**SUB:- STUDY REPORT ON HIGH SHAFT VIBRATION PROBLEM OF
TURBINE GENERATOR OF RIHAND UNIT#4 (500 MW)**

**STUDY REPORT ON HIGH SHAFT VIBRATION PROBLEM
OF TG#4 (500 MW)
AT
RIHAND STPS [6x500 MW]**

**RIHAND SUPER THERMAL POWER STATION
NTPC LIMITED, RIHAND, (UP)**

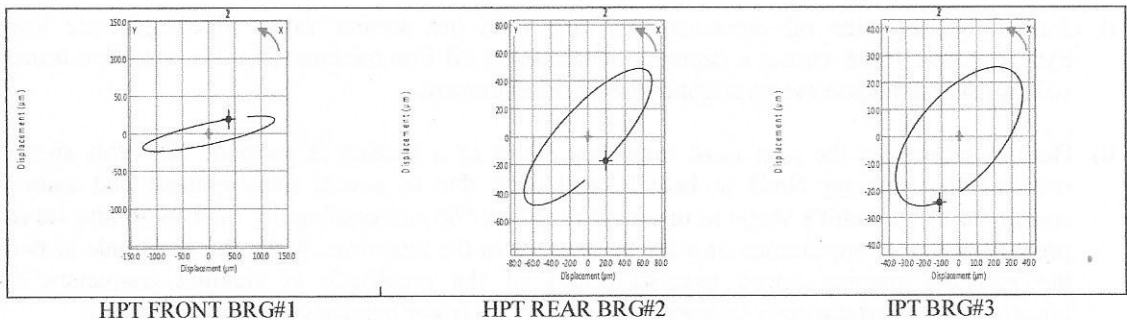
- iv) The swing check value recorded after final assembly was very high in the 1st set of readings more than 150 microns whereas in the 2nd set readings around 90 microns. If we take average of these two readings, it will come around 120 microns, indicates built in eccentricity in the system, therefore HPT front shaft vibration are showing high in the beginning and maintaining high at various loads. This needs to be looked into seriously.

- i) Inspect all the Bearings of HP, IP, LP, Gen front for any abnormality. Check all the bearings for self - alignment & its seating and maintain proper clearances.
- ii) HP turbine has to be inspected/ replaced with the available module. Check swing value, which is an indication of high eccentricity, reduce to as minimum as possible.
- iii) Check HP & IP coupling alignment
- iv) As IP rotor is highly preloaded/misalignment, check IP rotor internals for any partial rubbing or contact,
- v) The coupling alignment of all rotors should be checked after removal of high points on the couplings faces.
- vi) Carryout roll checks of HP & IP for centering.
- vii) Check the catenary as per protocols.
- viii) LP-Gen Coupling faces have to be blue matched.

Figure No 1

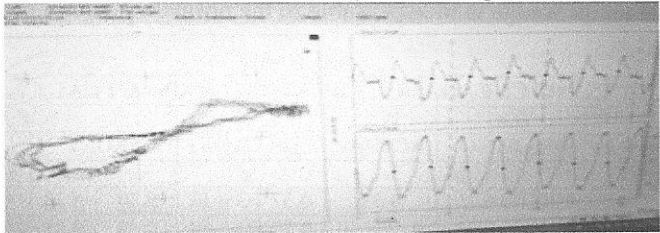
- vi) The Orbit plot taken during the load at 410 MW on 15th August 2019 indicated that Brg No 3 is highly preloaded, confirmed by orbit shape to resemble character "8" and causing the shaft to go into reverse precession due to appearance of a 2X component in the response.

Figure No 1 indicating higher amount of preload on the rotor which causes the orbit to become more elliptical and distorted. This is where the spring constant is much higher in the opposite direction to the pre-load than in the perpendicular direction to the preload. This produces the classical twice per rev frequency associated with alignment.

BRG No #3 Direct Orbit (Banana shape)
